Council Reference: GT1/52  
Your Reference: MP06\_0316

**Comments on the Addendum to the Preferred Project Report -  
Concept Plan and the Preferred Project Report for the Project  
Application for Cobaki Lakes**

Council officers have reviewed both the Addendum to the Preferred Project Report for the Concept Plan for Cobaki Lakes and the Preferred Project Report for the Project Application for the central open space and drainage corridor.

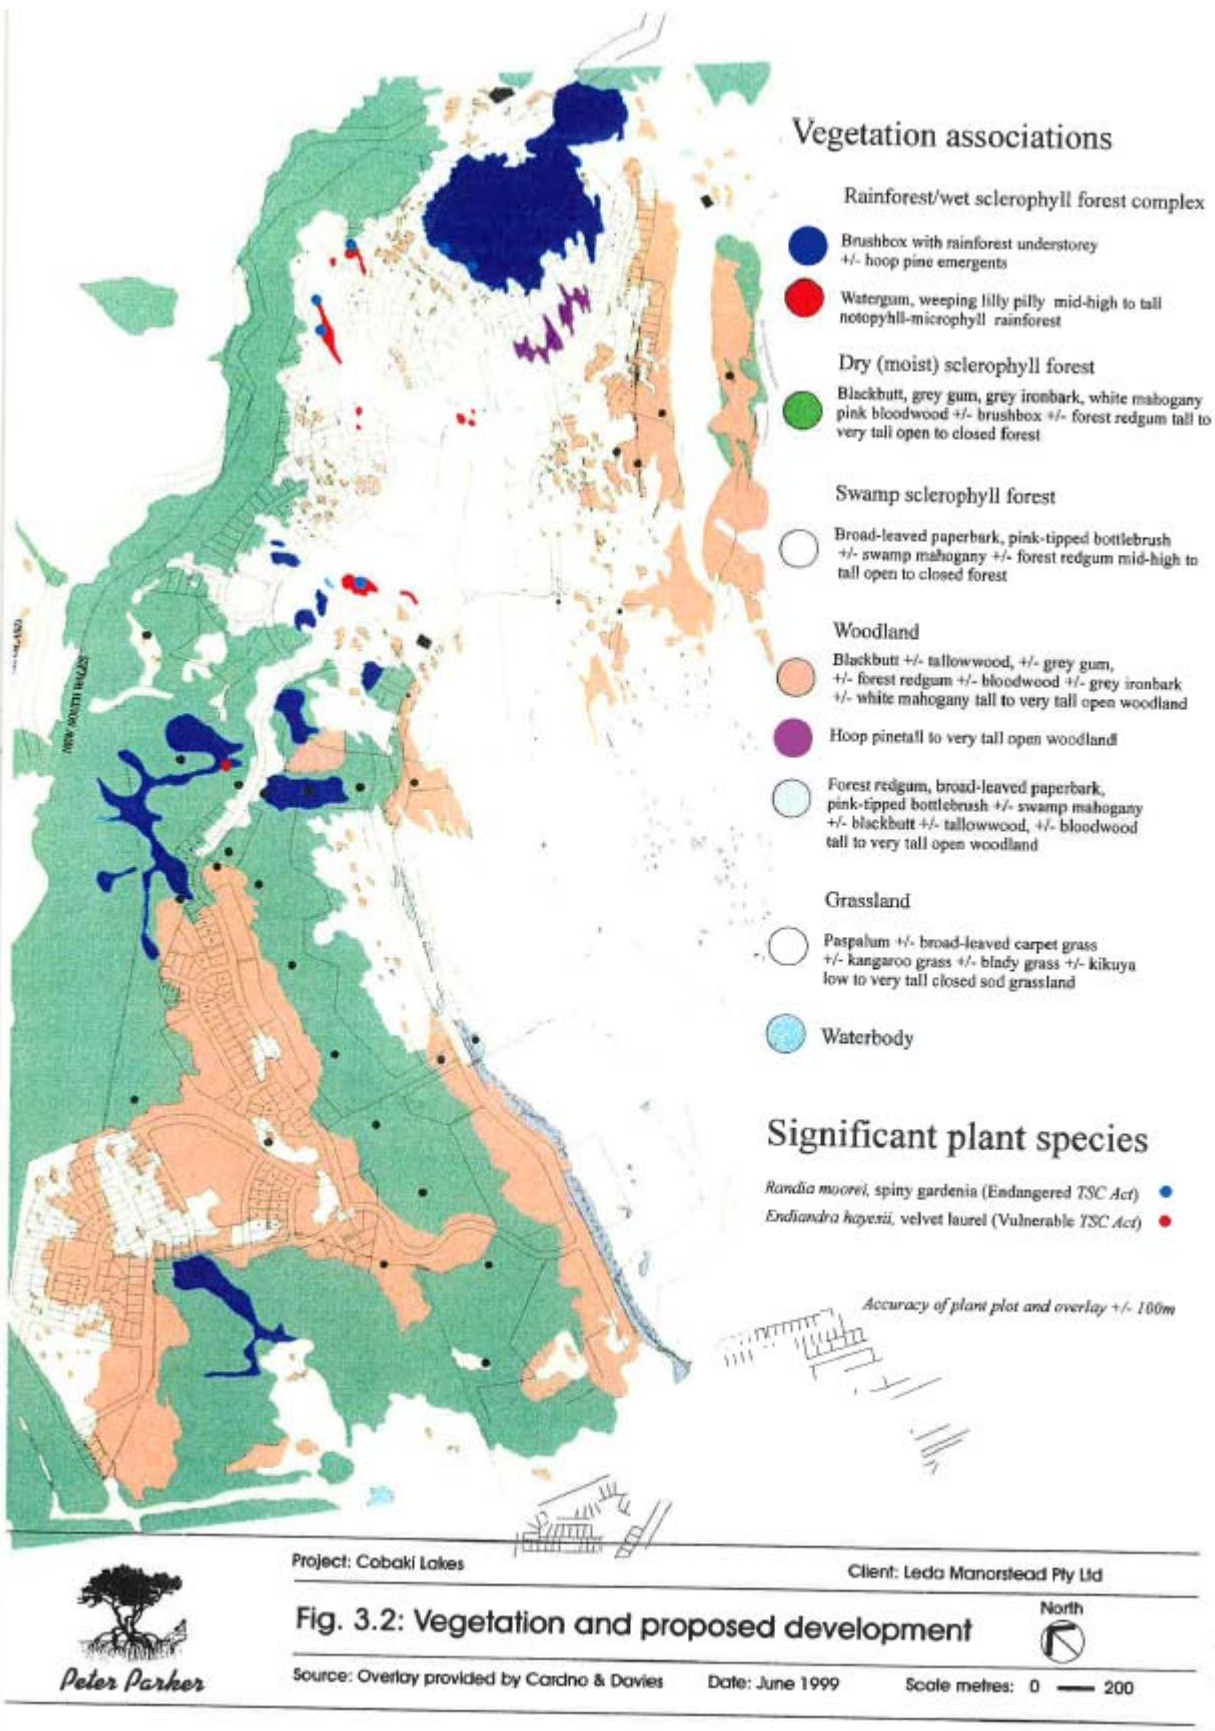
Proposed offsets do not include offsets already required by existing approved development consents. The Ecological Assessment and Assessments of Significance have based conclusions with regard to impacts and calculation of offsets upon consideration of the site as it currently stands. Earthworks already undertaken on the site were approved by Council on the basis of significant habitat retention, protection and restoration as offsets to the impact of those earthworks.

The current reports do not consider these previous requirements, nor what appears to be loss of species that were to be retained (see for example an extract below from a Species Impact statement which illustrates threatened plants and old growth trees to be retained on part of the site) and appear to discount values and required offsets if areas or species are contained within areas already subject to development consent. Overall, this has resulted in undervaluing the ecological value of the site and thus reducing required retention or offsetting measures by which the development can be considered as not having a significant impact on threatened species, populations or ecological communities. If the earthworks completed to date are to be approved within the Concept Plan approval then the ecological requirements that accompanied the relevant consents must also be undertaken in addition to offsets calculated upon Concept Plan impacts.

Existing consent conditions relating to the three main development consents over the site that have approved the earthworks undertaken to date are repeated below and are relevant to issues raised elsewhere in Council's submissions to the Department of Planning. Most of the environmental conditions have not yet reached their hold point, which is generally release of a subdivision certificate. Thus, earthworks that were approved based on offsets to be undertaken
